STAFF RECOMMENDATION

1700 Dorothy Place

Application: New construction-infill, Setback reduction

Description of Project: The applicant proposes to construct a two-story office building facing Dorothy Place. As part of a separate application, they also propose an addition and outbuilding to the neighboring historic building facing 17th Avenue South. The two projects will be connected by a six foot (6') wall facing 17th Avenue South.

1 EE - House - West
1/8" = 1'-0"

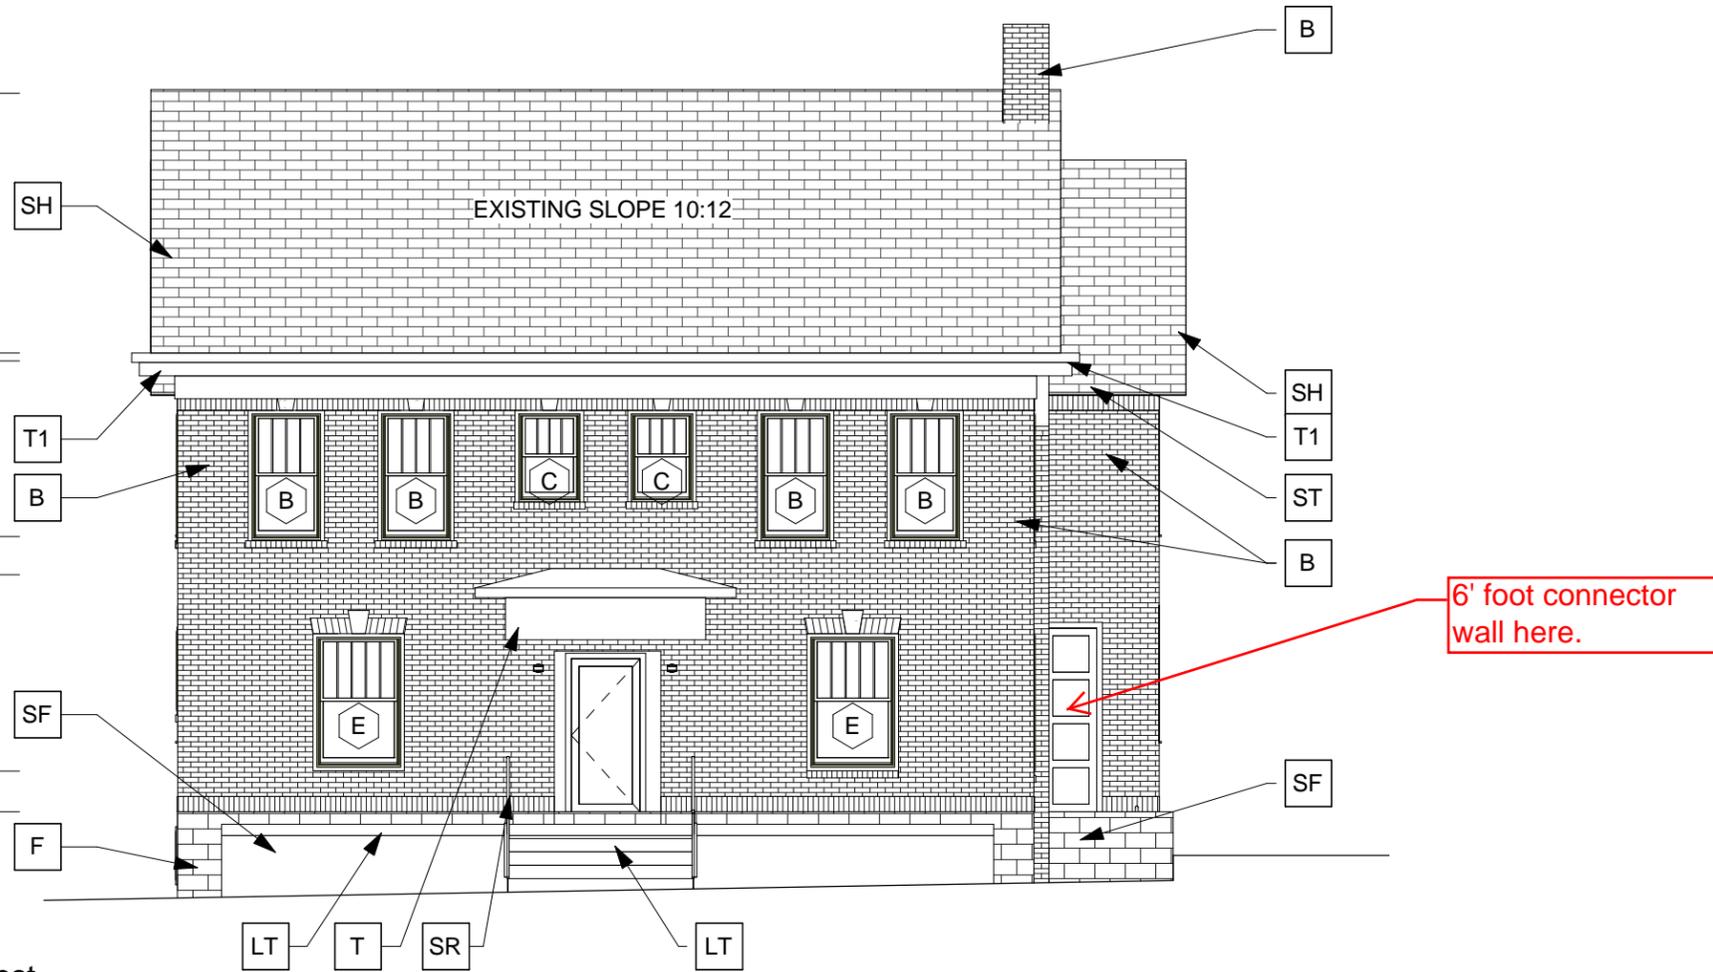
6' foot connector wall here.
